York Street Interchange

Vector Re Routing
Proposal
Assessment

October 2015

Figure 1: Vector Proposal

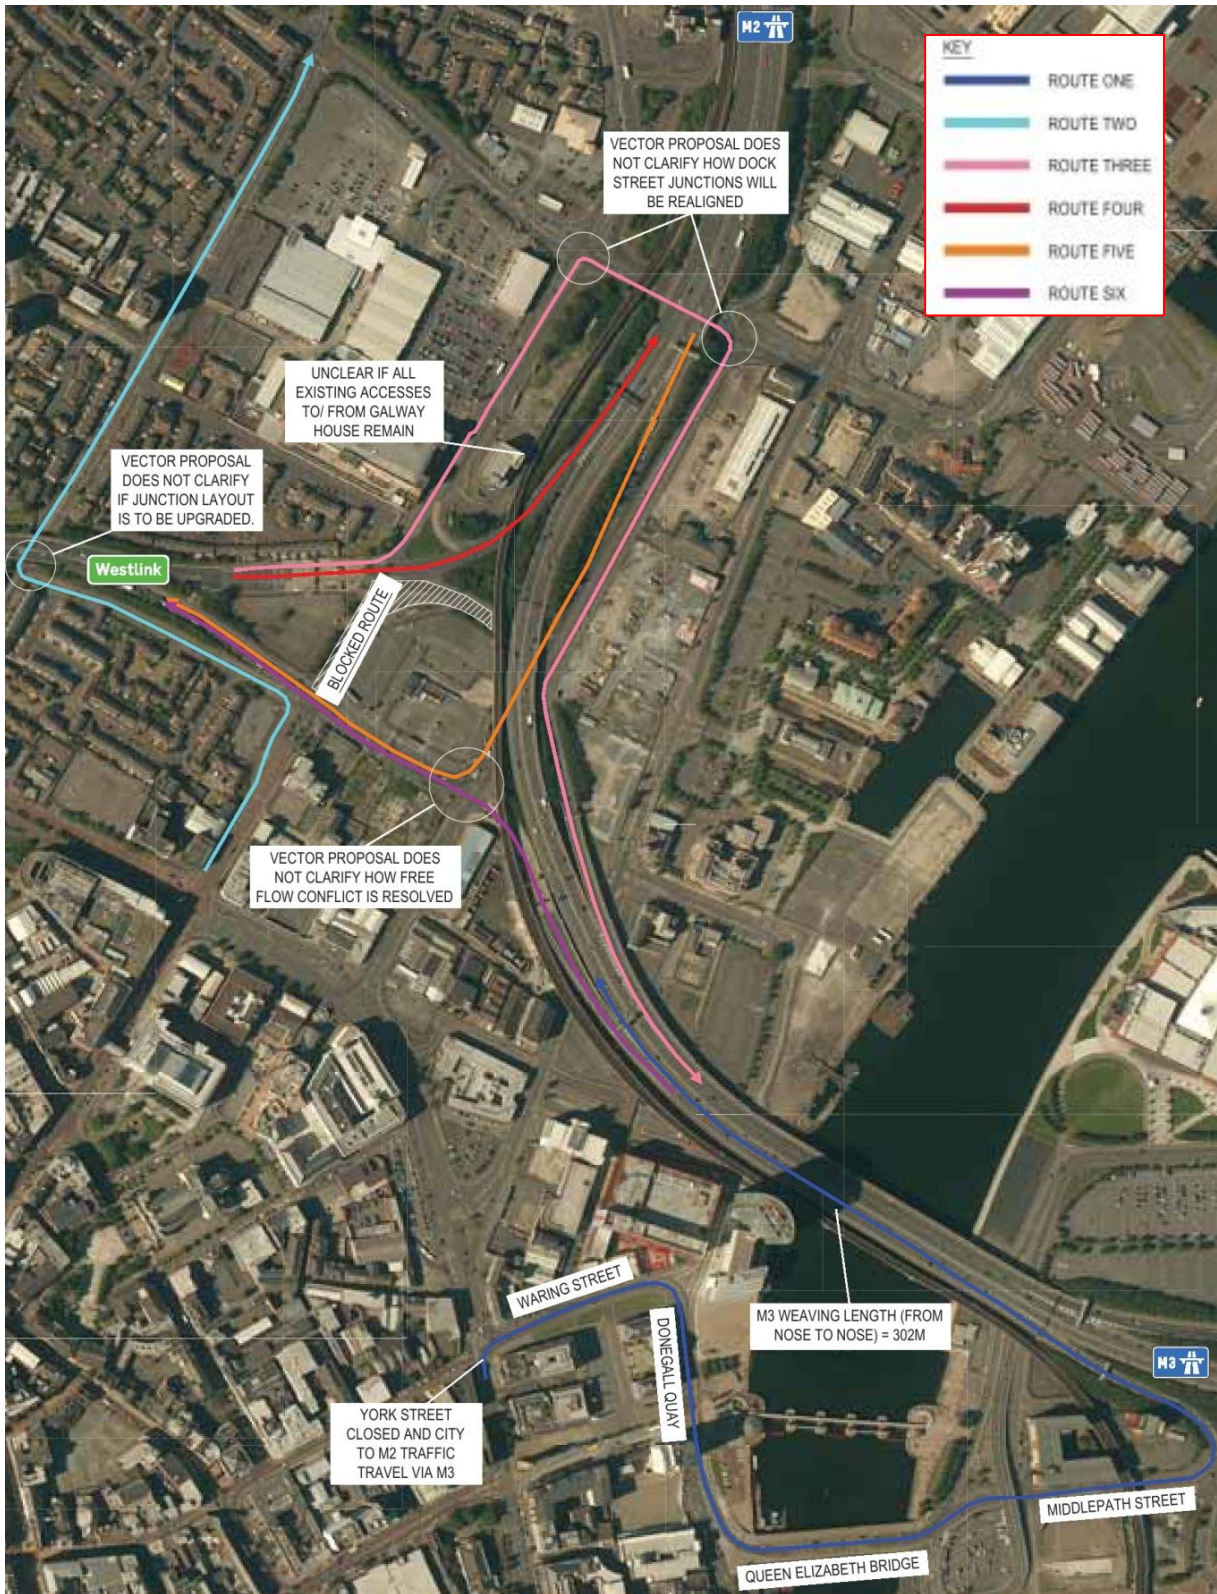
The Vector Proposal identifies six routes for traffic movements which are intended to remove the requirement for the existing signalised gyratory junction. These routes are illustrated in Figure 1.

- The Vector Proposal requires significant changes to several existing signalised junctions. A number of these junctions would adopt an unconventional layout and it is unclear how these changes can be introduced in line with the engineering standards of the Design Manual for Roads and Bridges.

- Higher speeds and free-flow traffic may lead to greater risks for the safety of road users, particularly where free-flow is being introduced on unconventional junction arrangements.

Drawing Title
VECTOR RE-ROUTE PROPOSAL ASSESSMENT: ROUTE TWO

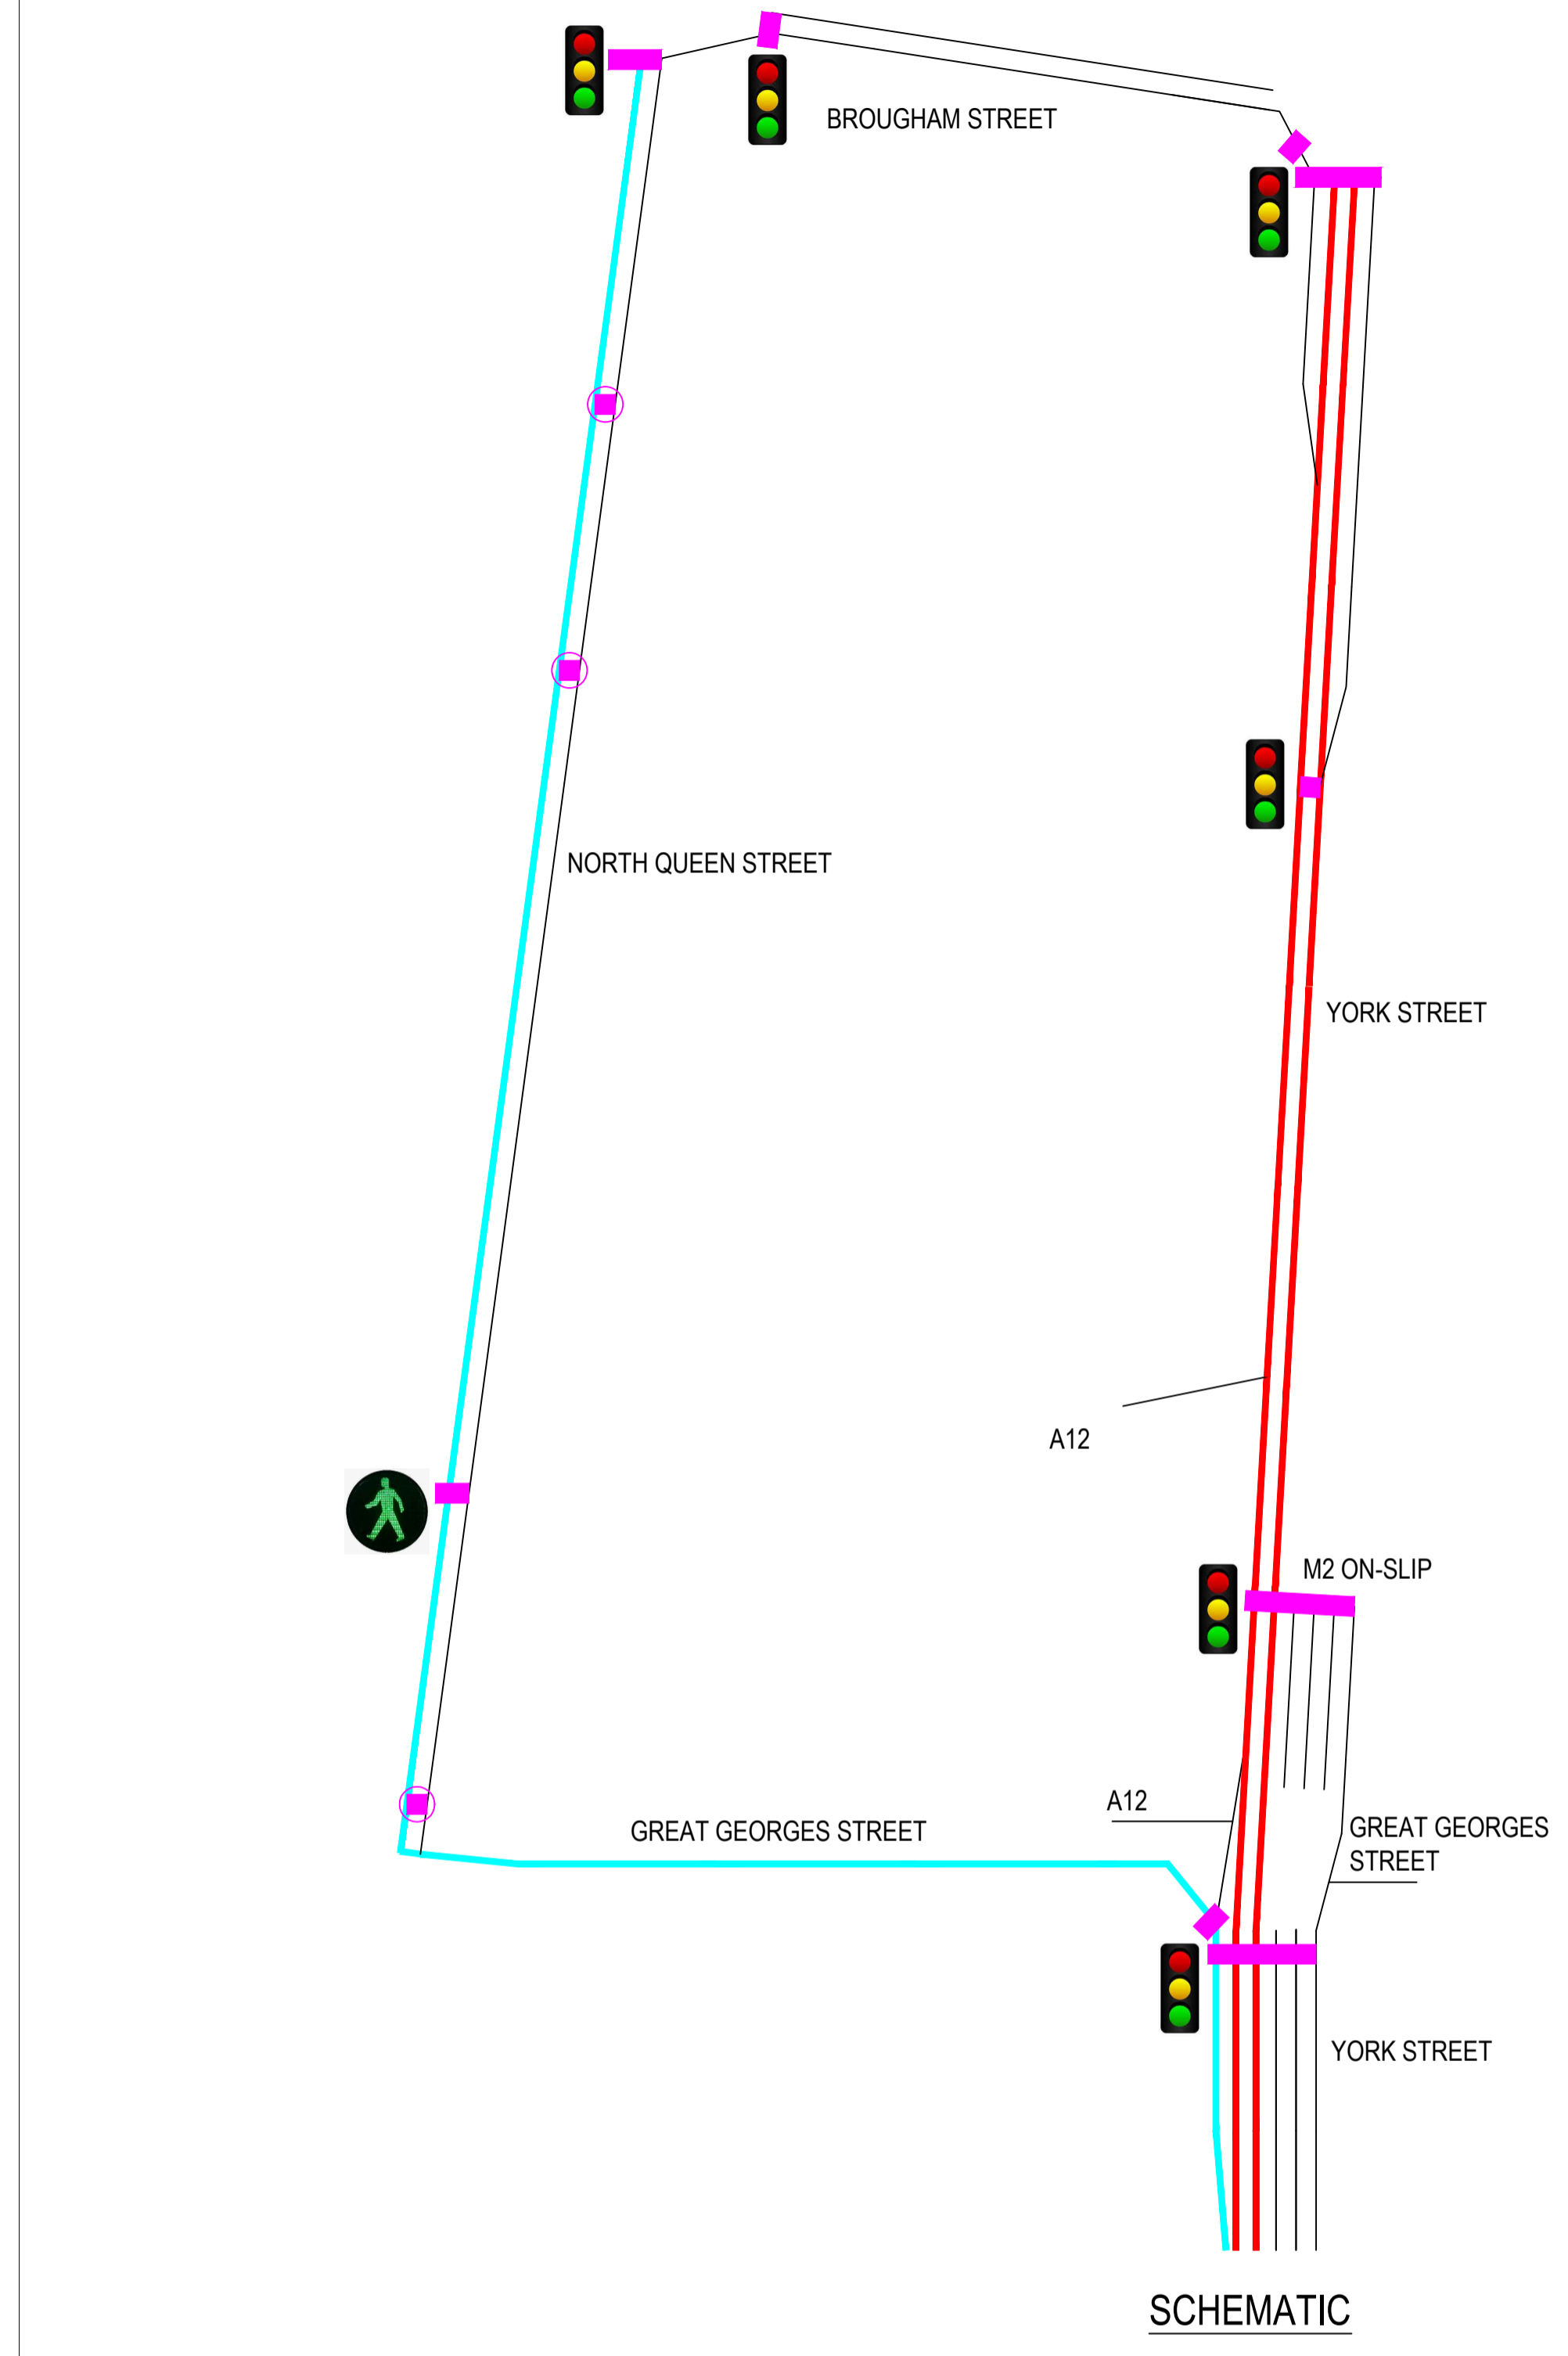
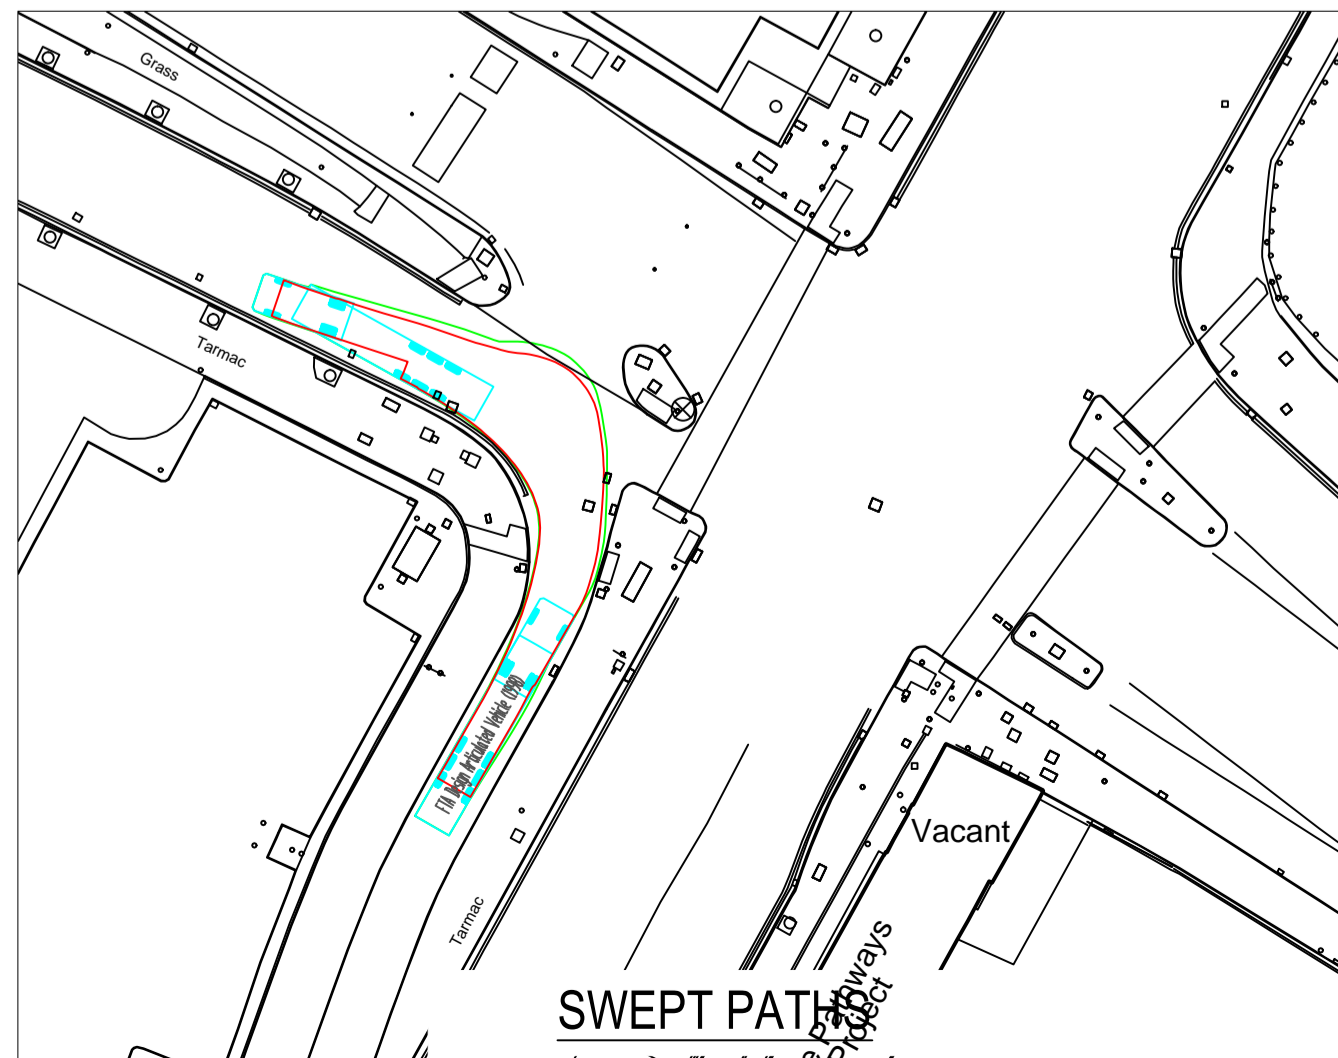
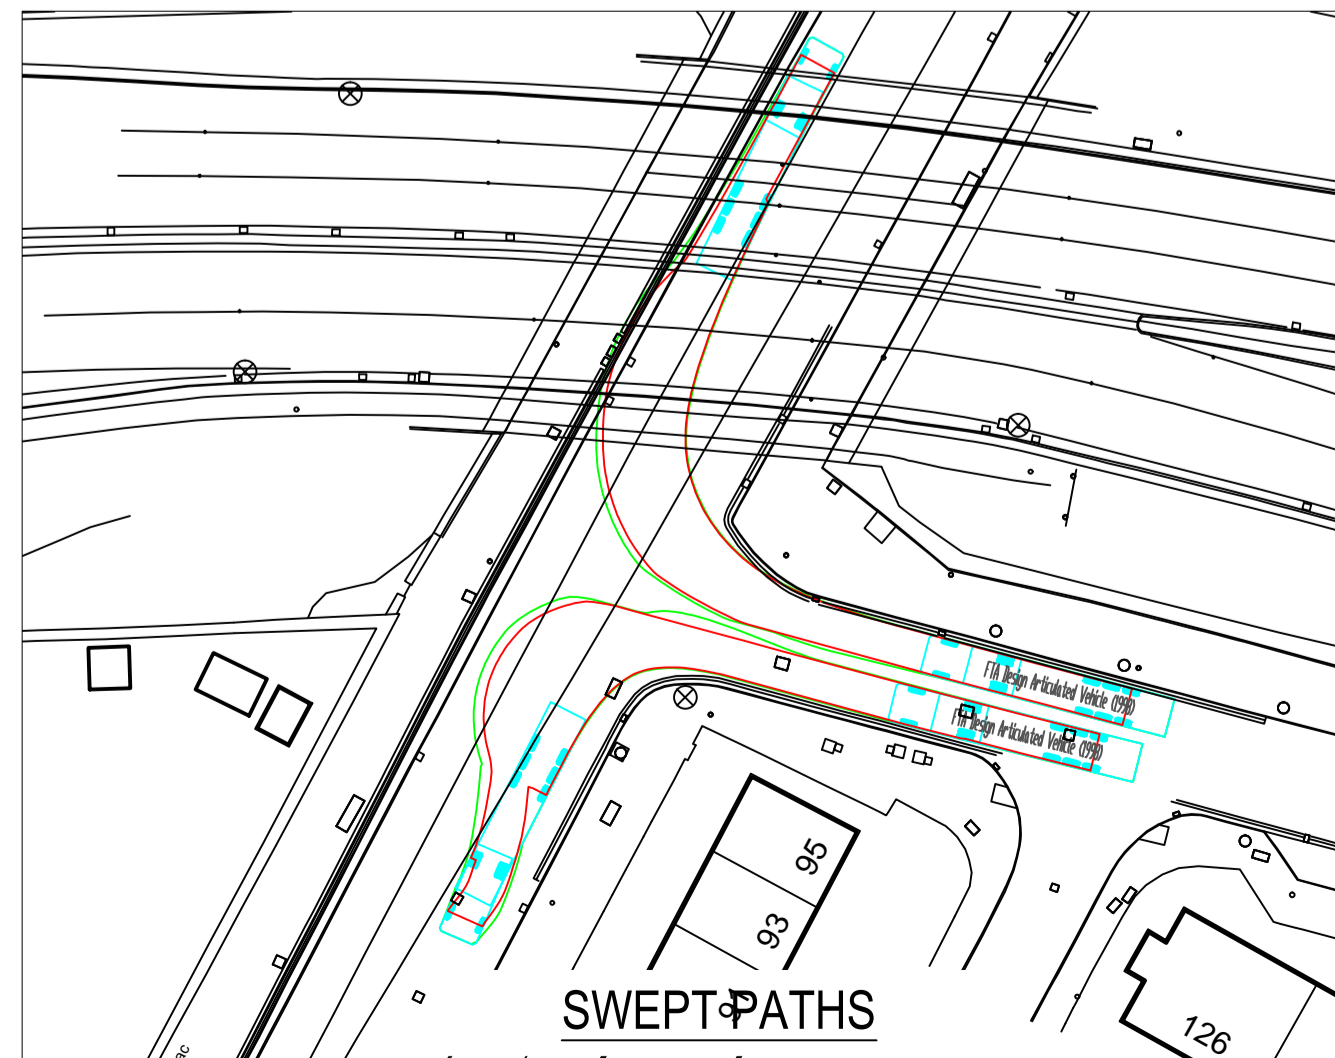
Drawing 2 in Appendix A illustrates the Vector Proposal, along with a schematic diagram illustrating existing lane provision on the original and diversion routes.

- the management of conflicting movements between the re-directed traffic on Great Georges Street as it joins traffic flows on North Queen Street;
- the ability for pedestrians to cross Great Georges Street along its length or indeed at the junctions at North Queen Street and York Street (in the absence of signal controlled crossings);
- the envisaged lane configuration on Great Georges Street is unclear from the information provided. Currently this operates as a wide single lane of approximately 9m (with on-street parking). This is illustrated in Figure 2;

- The envisaged lane configuration on North Queen Street is unclear from the information provided. Currently this operates as a single carriageway and it is noted that this has been subject to traffic calming measures befitting its residential setting. This is illustrated in Figure 3;

- from a swept path analysis of the existing route, as illustrated on Drawing 3, it would not be possible for two lanes to be continuously provided between the junctions at York Street and North Queen Street;
- the Vector Proposal may introduce lane configuration requiring the extension of parking restrictions on Great Georges Street. This would require a period of public consultation and would be anticipated to meet with resistance from representatives of the local communities;
- it is considered that the re-routing of significant traffic volumes onto these existing residential routes introduces additional risks for road user safety, particularly non-motorised users; and
- the severance of York Street as part of Route 2 will impact upon existing public transport services for the area.
